RESOLUTION R-24-16

A RESOLUTION APPROVING PRELIMINARY PLAT FOR STONER PRAIRIE.

Application: PP-2092-15

Planning Staff Review #4

Sheet Title:
PHASING PLAN - OPTION 2
SANITARY SEWER FROM SCHUMANN DRIVE AND LACY ROAD

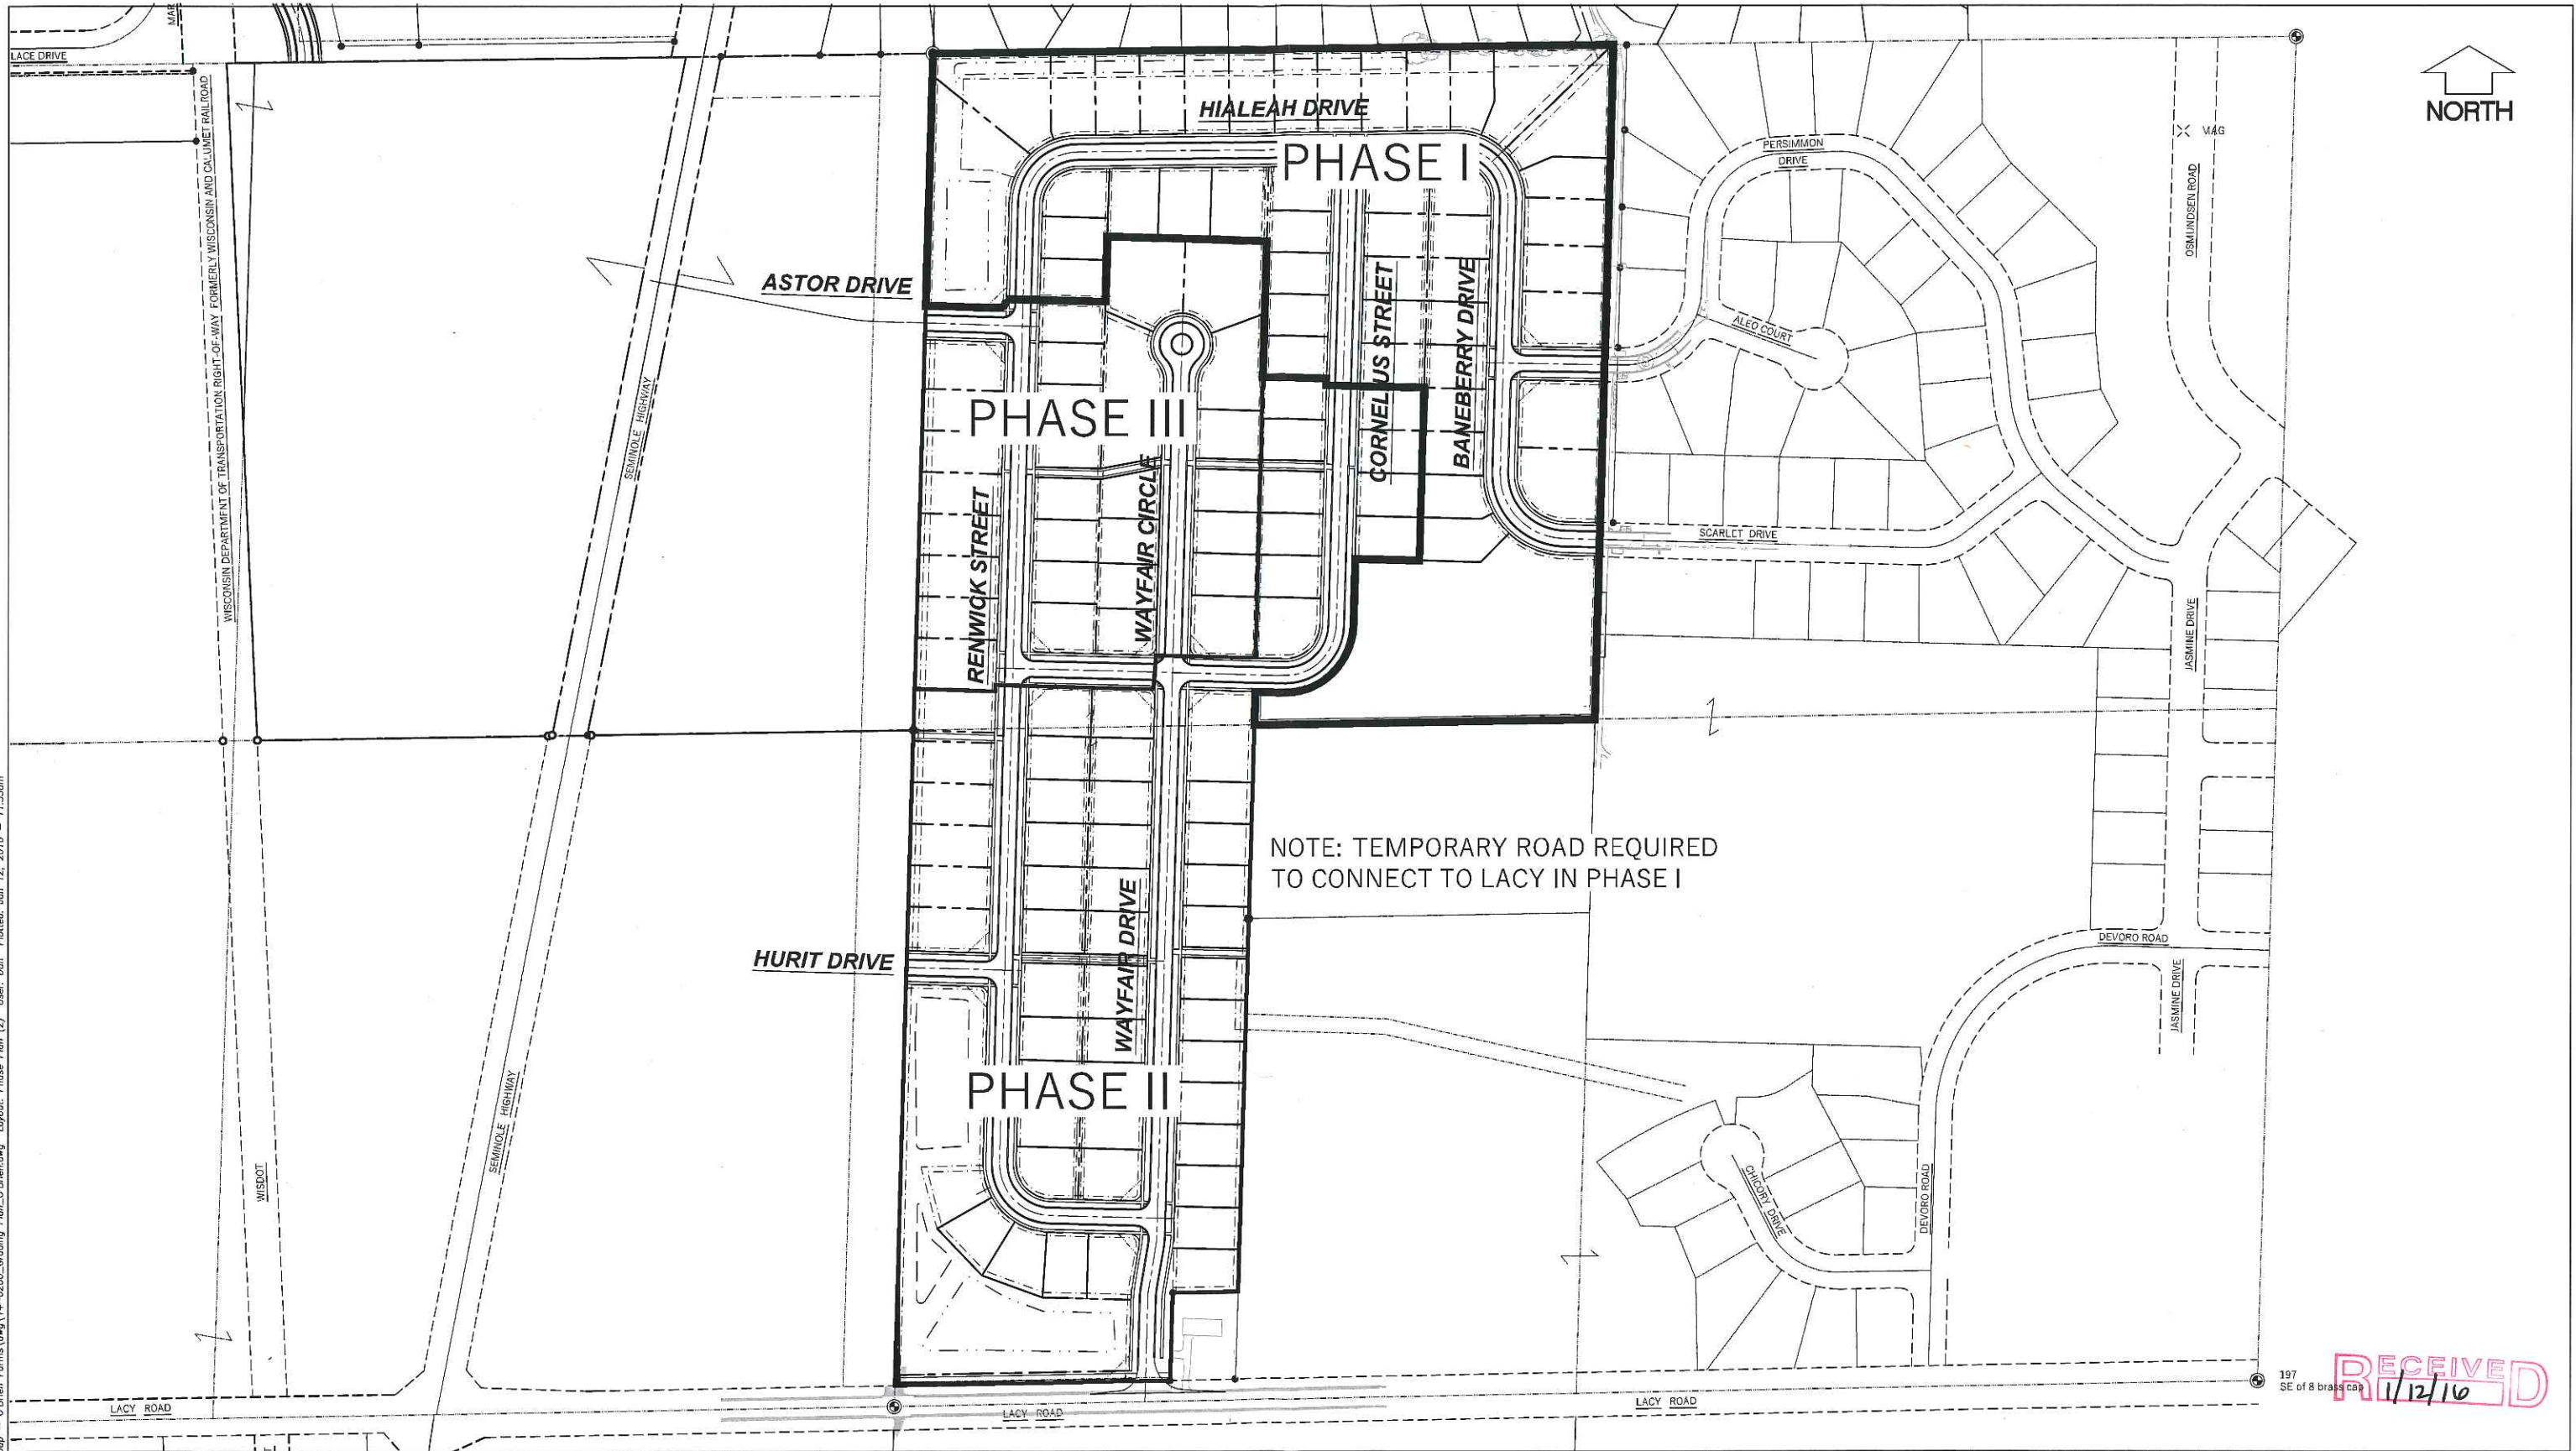
27. **Review #3: To approve a plat we need to know how sanitary sewer will be provided to the property. Conversations with a property owner provides little certainty as to how a sanitary line acceptable to Public Works will be provided to serve the property. Please work with Public Works to address this item.**

Review #4: Planning staff is agreeable to a condition being placed on preliminary plat approval related to sanitary if Public Works agrees and does not have any concerns. As part of the staging requirements, see section 24-2(j) of the Land Division Ordinance for additional details, please provide a staging/phasing plan. Staff understands that you may have two alternate phasing plans due to current sanitary capabilities and the desired sanitary easement. Please provide phasing plan(s) for review.

Please refer to the enclosed Phasing Plans as requested.
